PROJECT: JEDDAH OPERA HOUSE

TITLE: OPERA BUILDING
VERTICAL TRANSPORTATION
PART 001
PLANS - LIFT SHAFT (L08)

DRAWING No: JOH-OTS-S5-01-056-001-ZZ-SD-VT-011040 REV: S01

SCEC – K&A Reviewed
KHATIB & ALAMI — SAUDI CONSOLIDATED ENGINEERING COMPANY
Code B – Approved with Comments (Do not Resubmit)

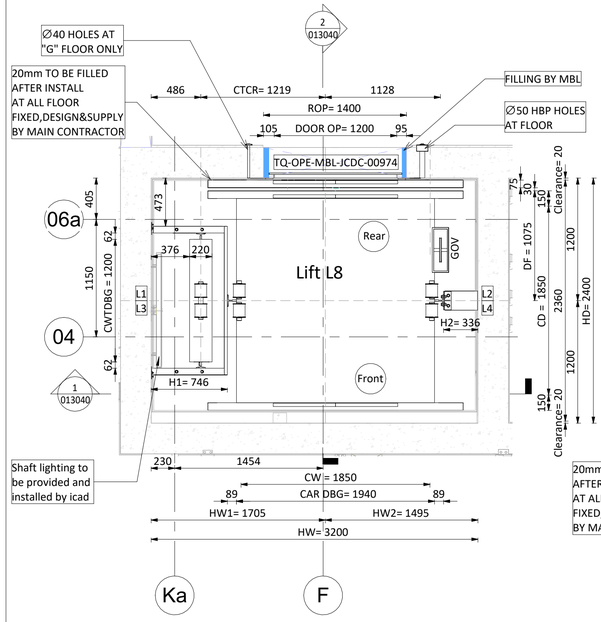
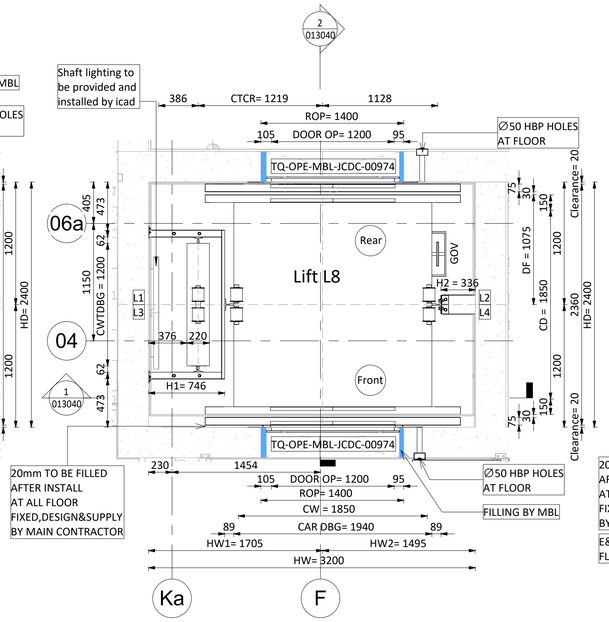
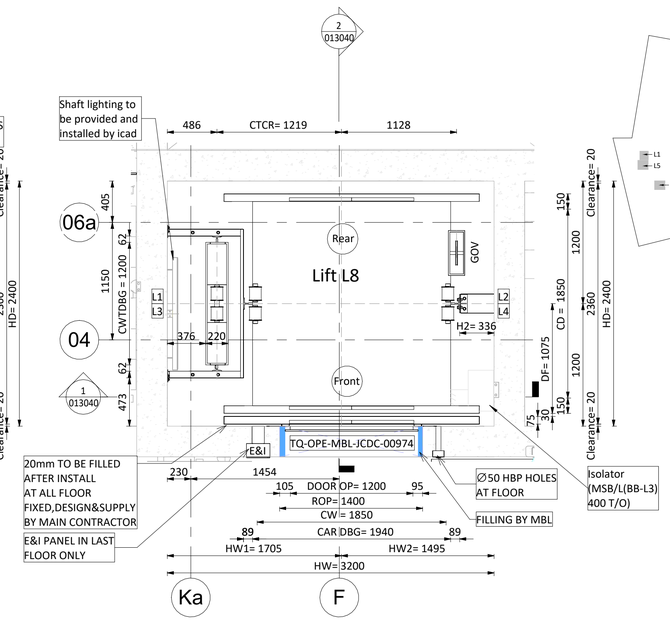
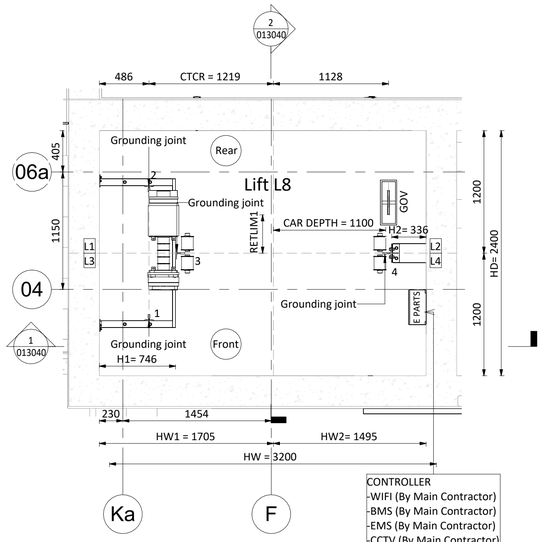
the Note provided on the drawing is rejected and the word (by client)shall be replaces to (by main contractor):

TITLE: OPERA BUILDING
VERTICAL TRANSPORTATION
PART 001
ELEVATIONS - LIFT SHAFT (L08)

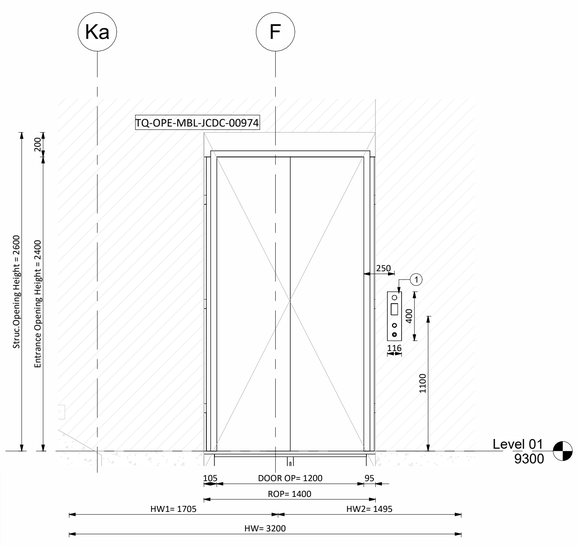
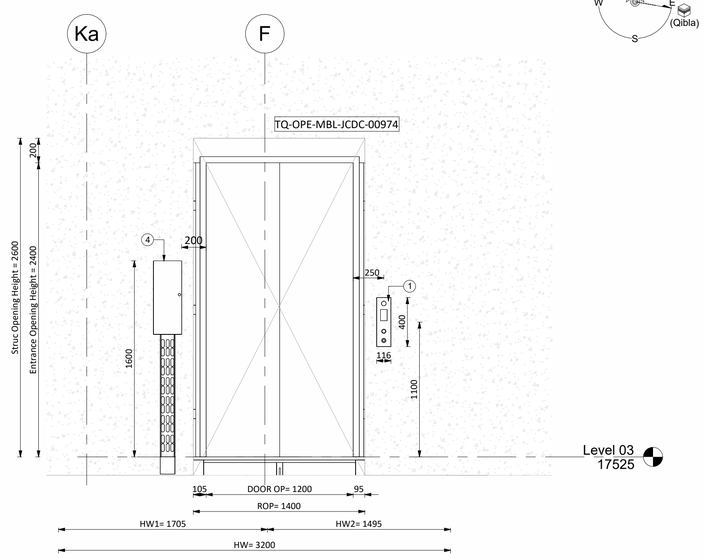
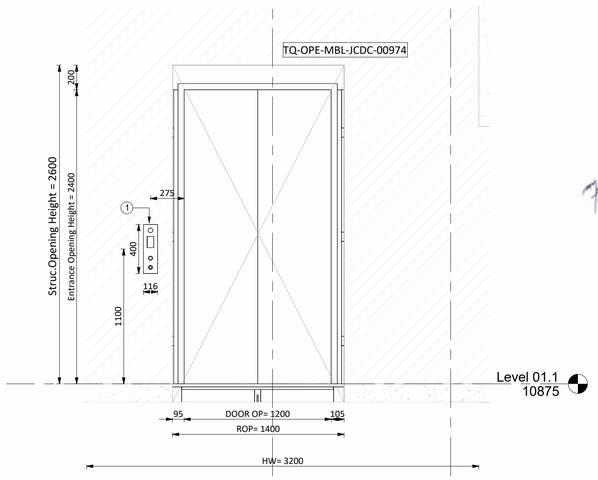
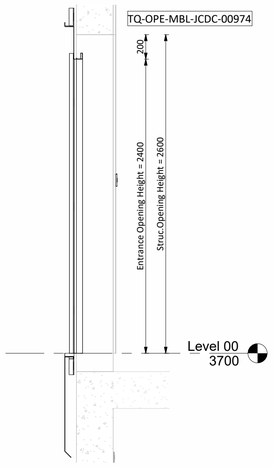
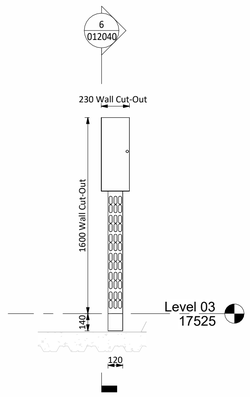
call button centerline height of 1100 mm is ok subject that the installation remains fully compliant with EN 81-70 and the applicable accessibility requirements
